ADDENDUM
PAGE 1 OF 1

OWNER:	Michigan State University 1147 Chestnut Road East Lansing, MI 48824
ENGINEER:	Fishbeck 5913 Executive Drive, Suite 100 Lansing, MI 48911
DRAWING REVISION NO.:	1
ISSUED HEREWITH:	
SPECIFICATION SECTIONS:	None
SHEETS:	2, 3, and 8
SKETCHES	None
BIDS DUE:	Not changed
This Addendum is issued to all Bid Set Holders, is a part of the Contract Documents, and modifies the previously issued Bidding Documents.

CAPITAL PROJ. NO.
CP23034

Sheet: 2 GPSTR 001 (reissued)

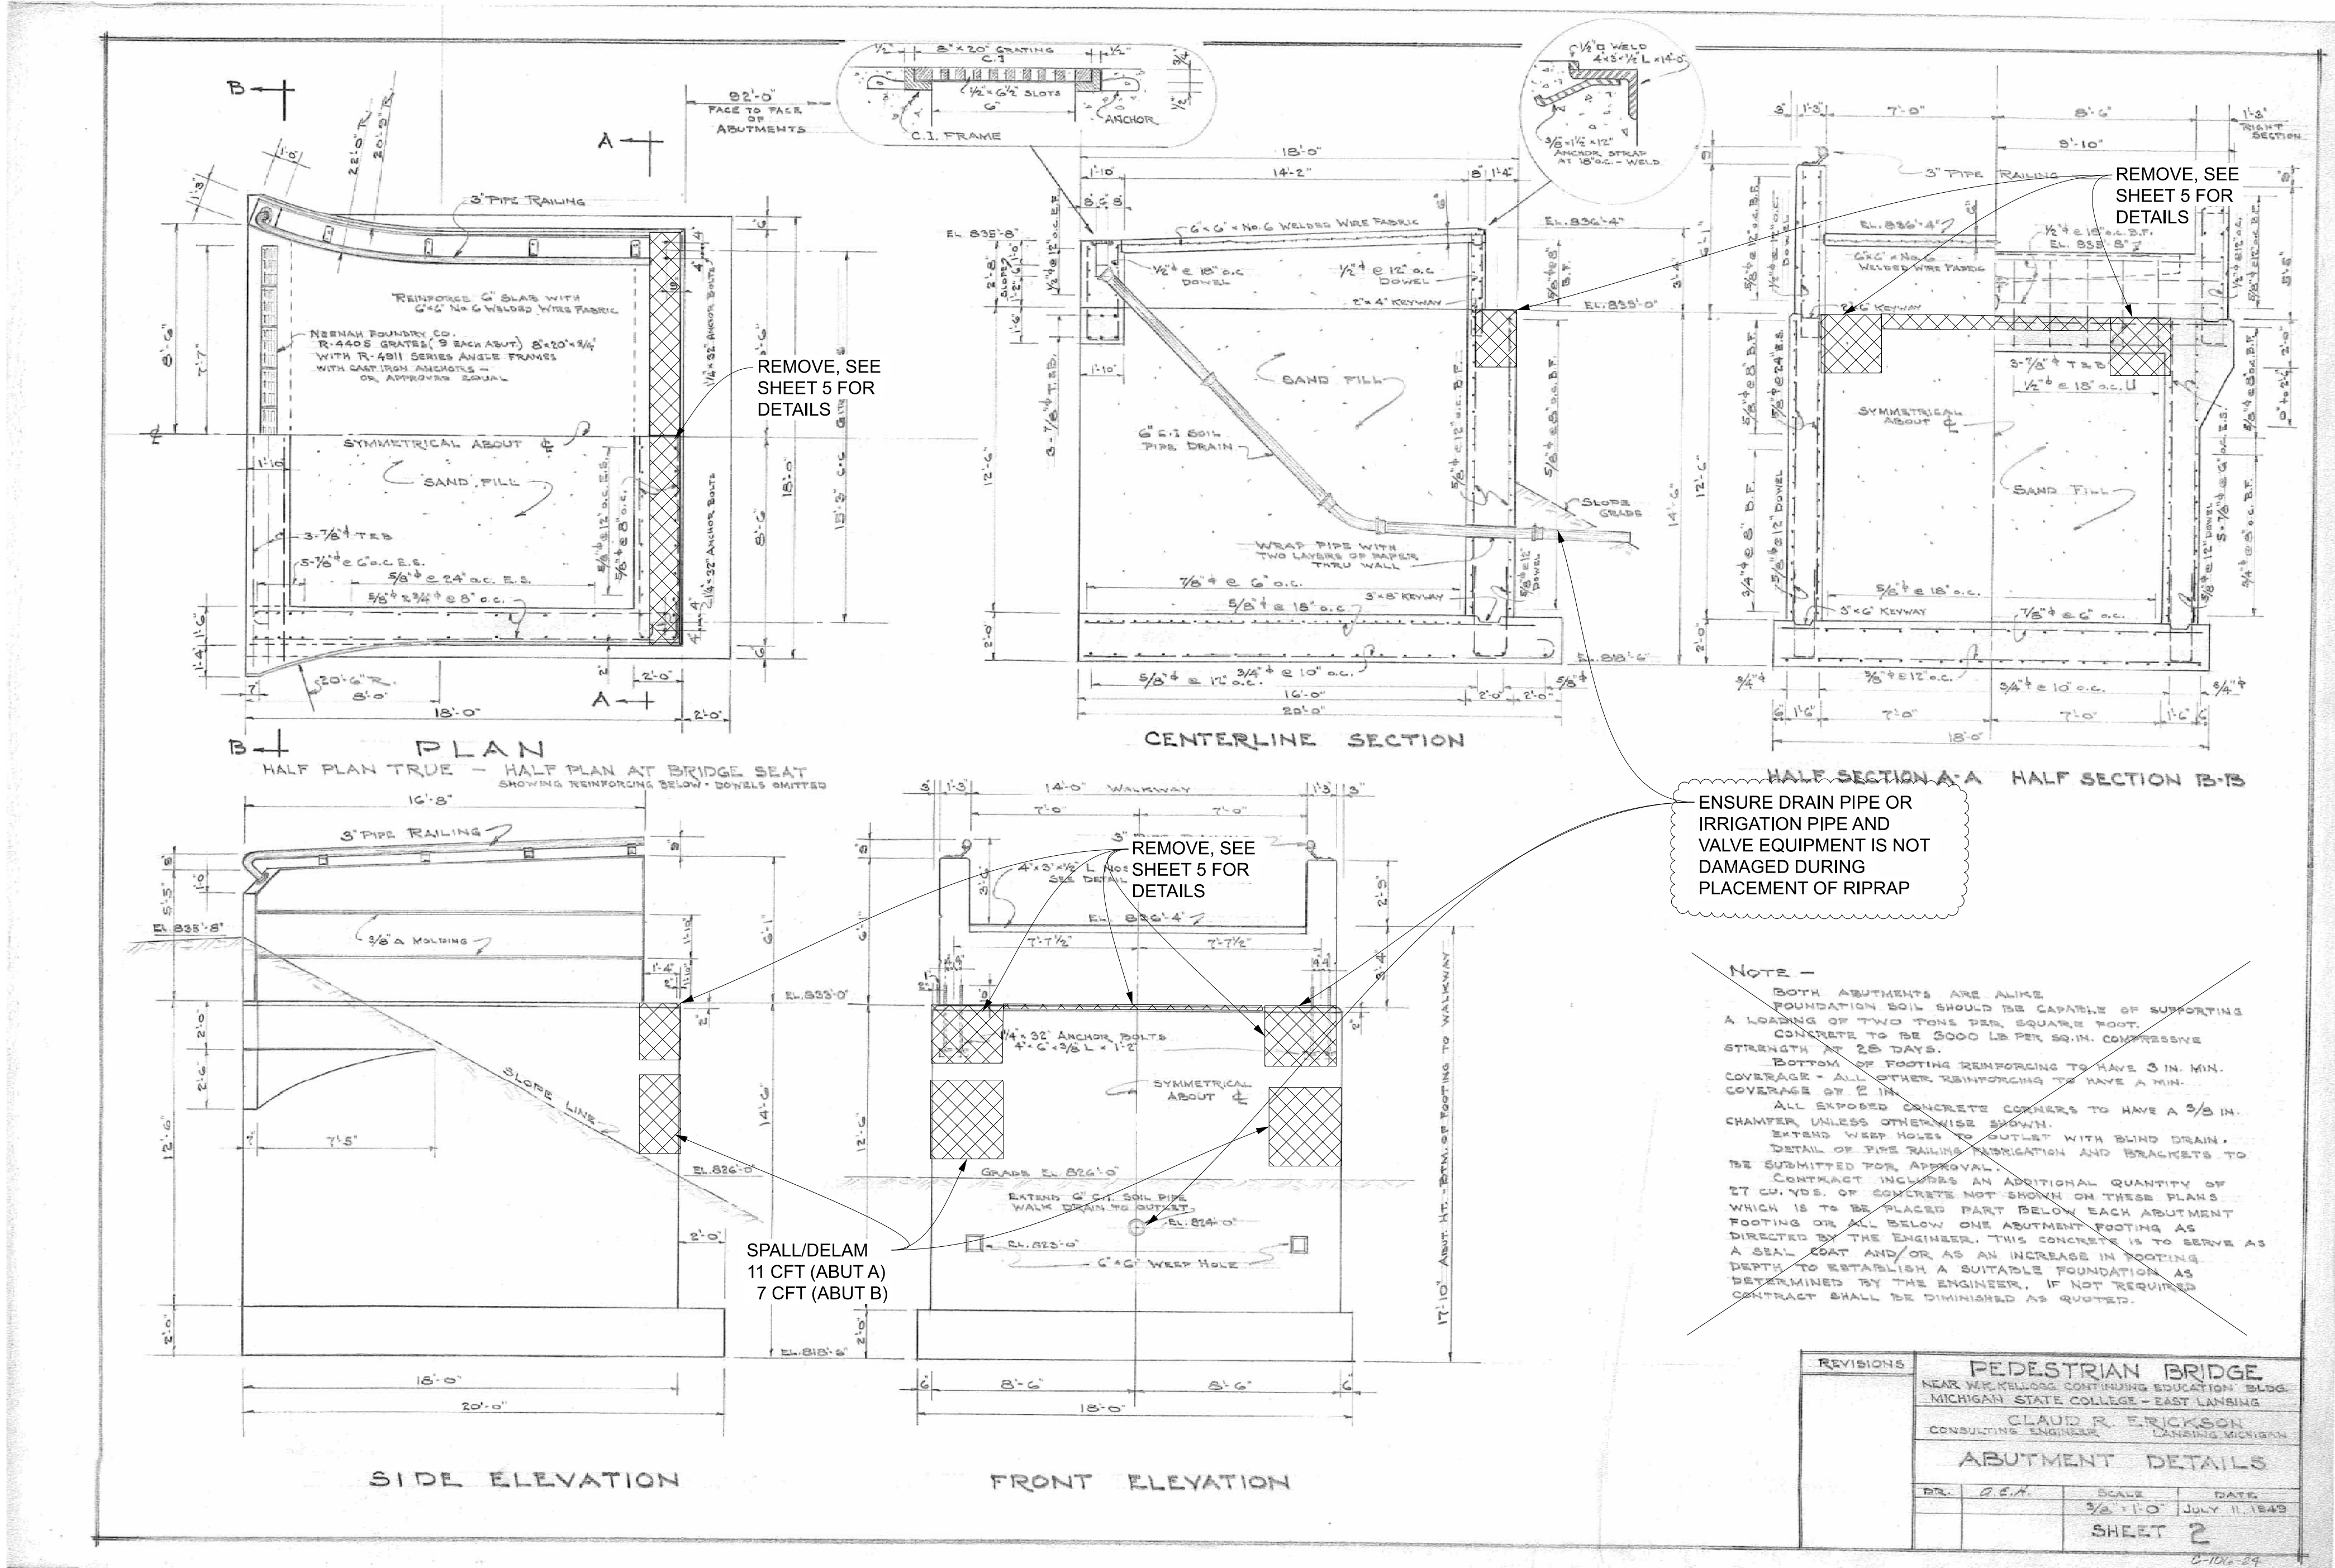
- A. Note added for allowable working limits in the stream with construction sequence notes for 2 stage construction if necessary to maintain working limits required for a minor permit. Pay items to be performed by MSU identified and a note was added below the quantity box As noted in bidding documents and discussed at the pre-bid meeting, this is a lump sum job. Pay items are solely for informational purposes.

** NOTE - MAX ALLOWABLE WORKING WIDTH IN THE STREAM IS NOT TO EXCEED 30FT TOTAL. IF MORE THAN 1/3 OF THE STREAM WIDTH WILL BE EXCEEDED BY THE TOTAL WORKING WIDTH THAN THE WORK IS TO BE DONE IN TWO STAGES AS SHOWN ON THE PLANS.

Sheet: 3 REM 001 (reissued)

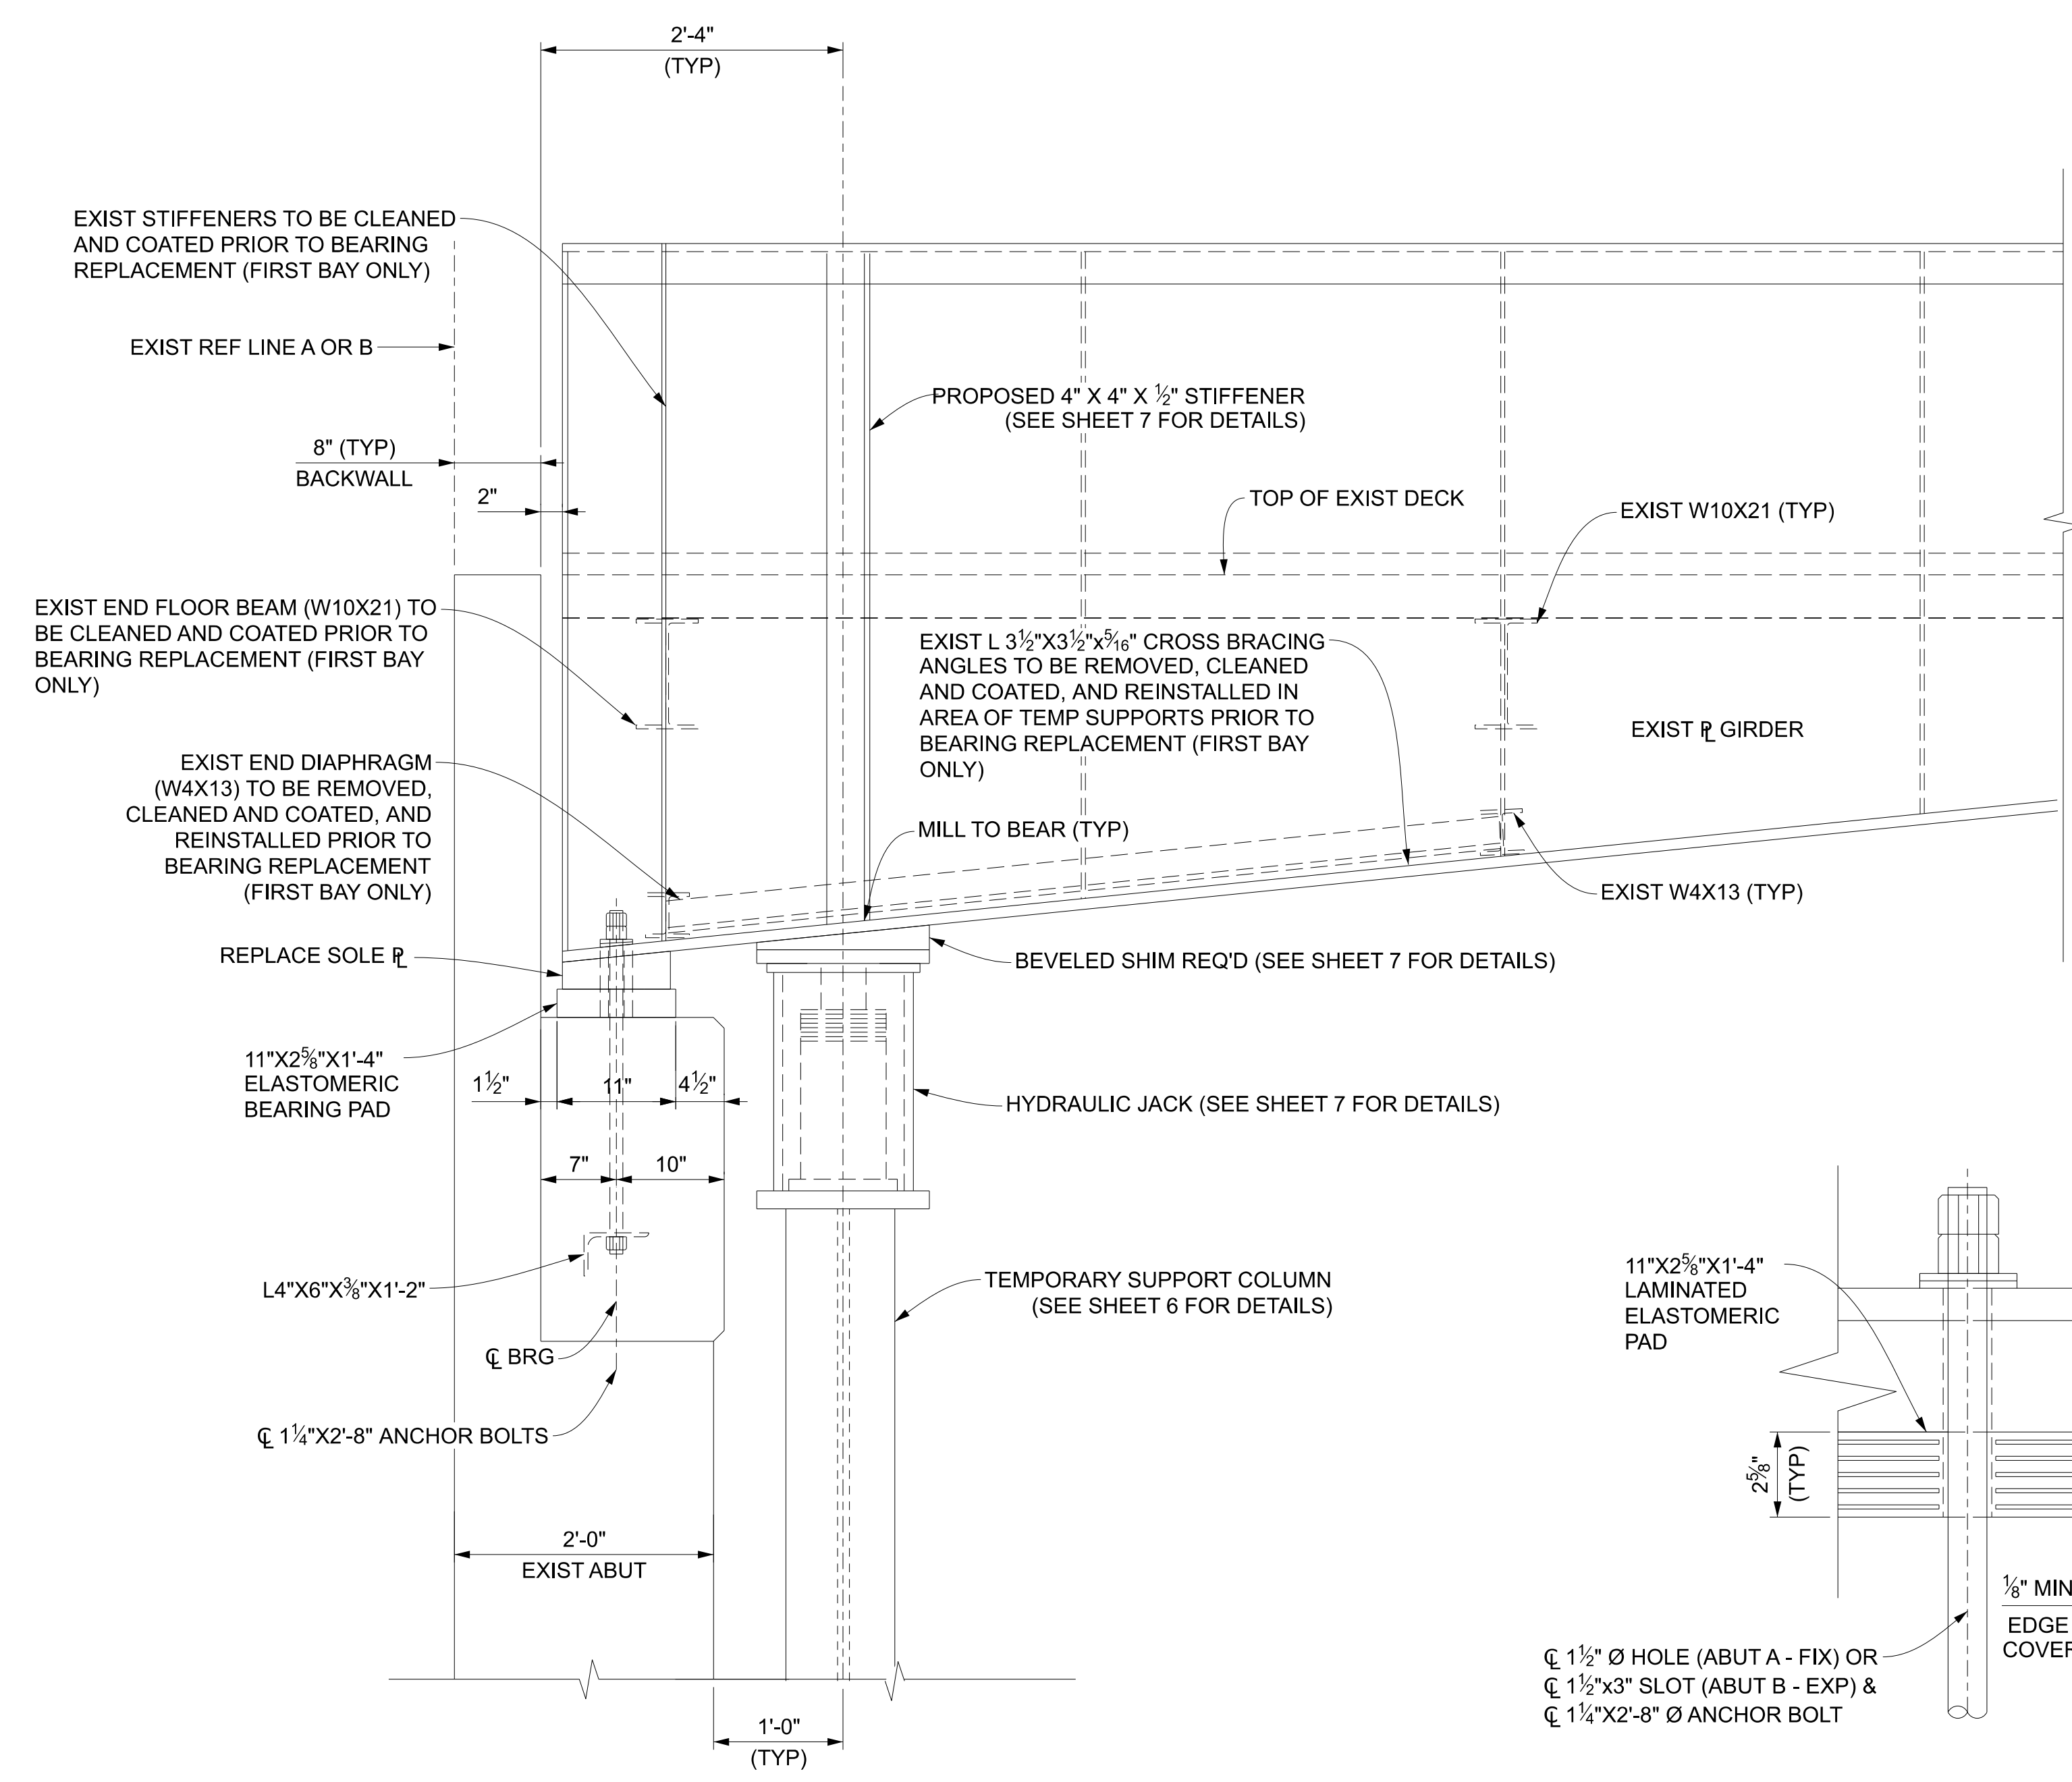
- A. Note has been added for ensuring the irrigation system piping and associated equipment along with the abutment drain outlets are not damaged during the placement of riprap in front of the abutments and during substructure repairs.

EXISTING DRAINAGE AND IRRIGATION SYSTEM PIPE CONNECTED TO THE ABUTMENTS ARE TO REMAIN. ENSURE UTILITIES CONNECTED TO ABUTMENTS ARE NOT DAMAGED DURING THE PLACEMENT OF RIPRAP.

TYPICAL SOLE PLATE DETAIL

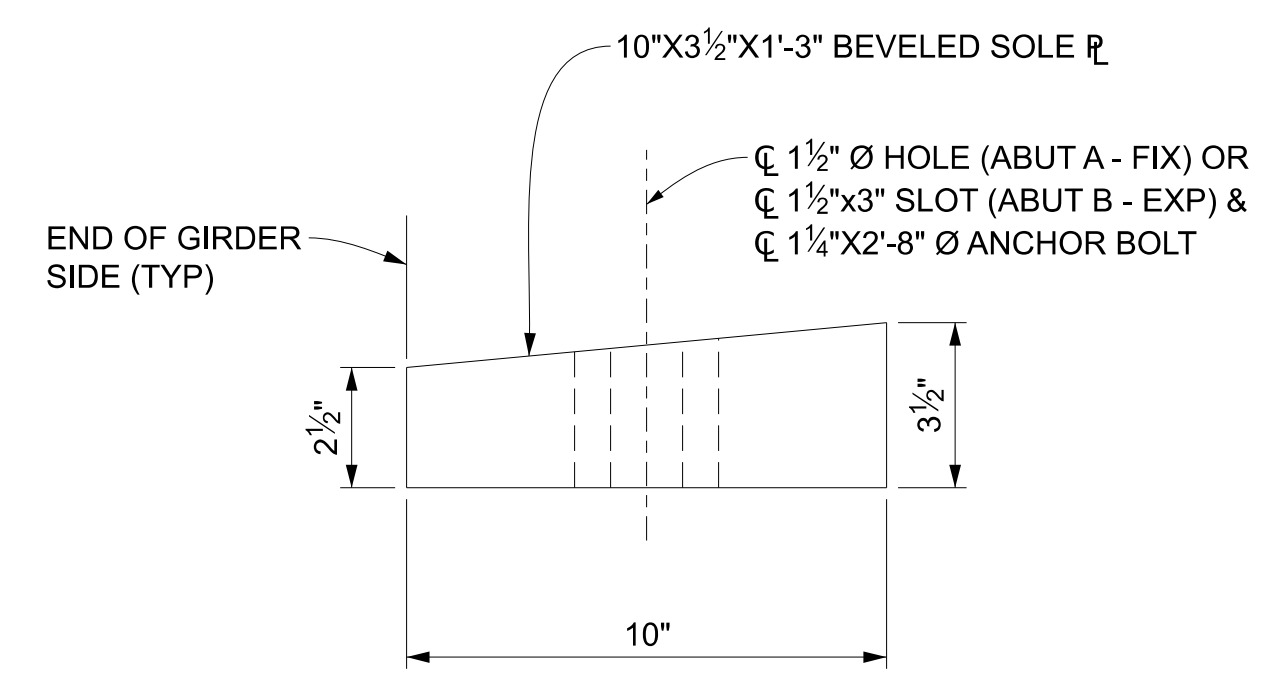
- A. Weld from bottom flange to new sole plate revised.
